Prior Approval: Si6 PZEV Engine Code 96 Excessive oil consumption

REF NO: TJ 28530.3.0	ISSUING DEPARTMENT: Technical Service	CAR MARKET: United States and Canada	
PARTNER: 3 US 7510 Volvo Car USA		ISSUE DATE: 2017-02-03	STATUS DATE: 2017-02-17
FUNC GROUP: 2100	FUNC DESC: Engine	Page 1 of 8

TJ Instruction VCC-475925-1

Title	Oil Level, adjustment	Page	1 (4)
Action	Product fix	Operation number:	36004-2 98518-2

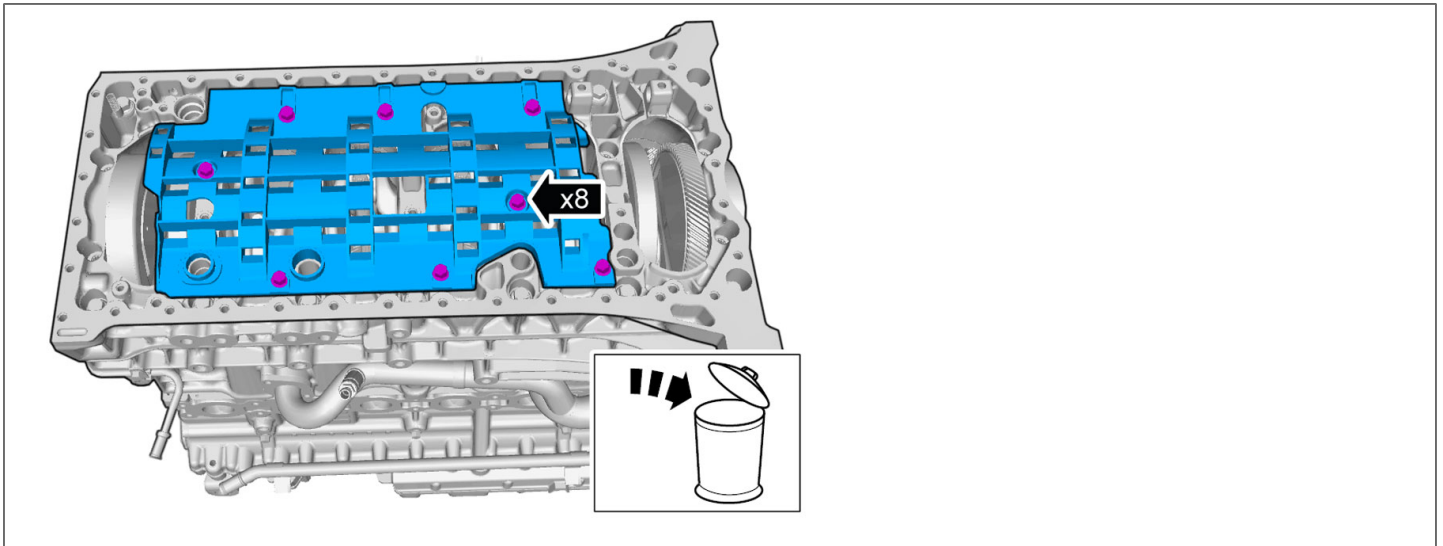
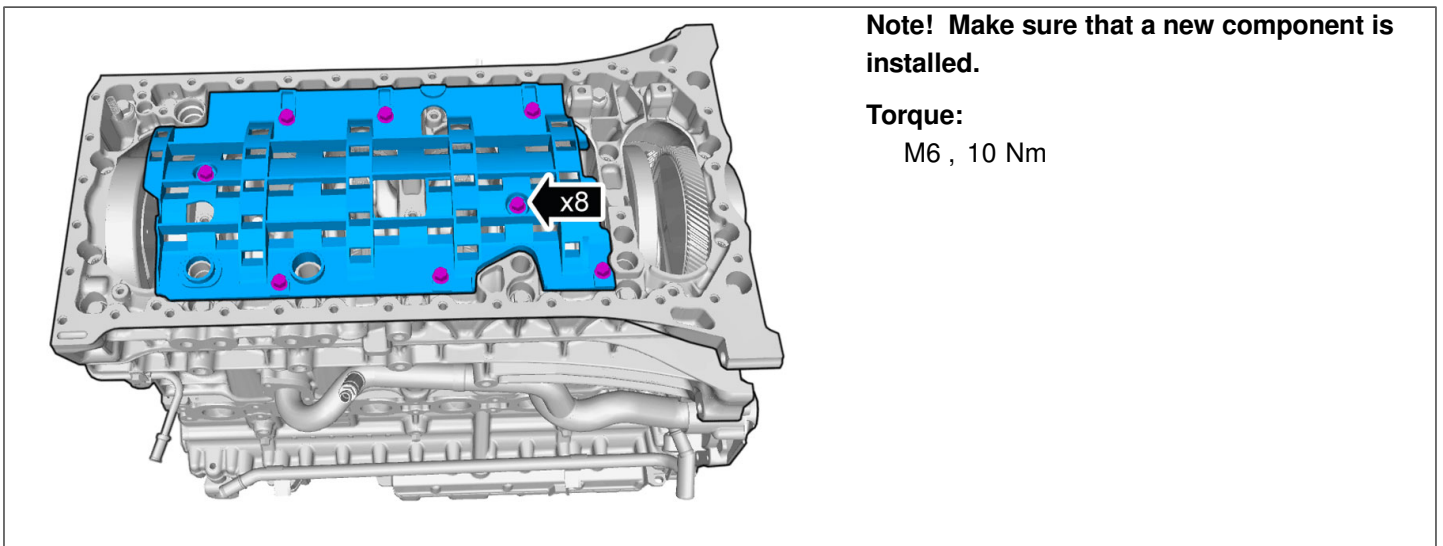
Replace oil pan splash plate and engine oil dip stick (included in kit, P/N 31430378) according to attached instruction, TJI-475925-1.

NOTE! Upgrade of ECM SW with these P/N is important to get correct oil level calibration to new dip stick.

Note! Make sure that a new component is installed.

Torque:
M6 , 10 Nm
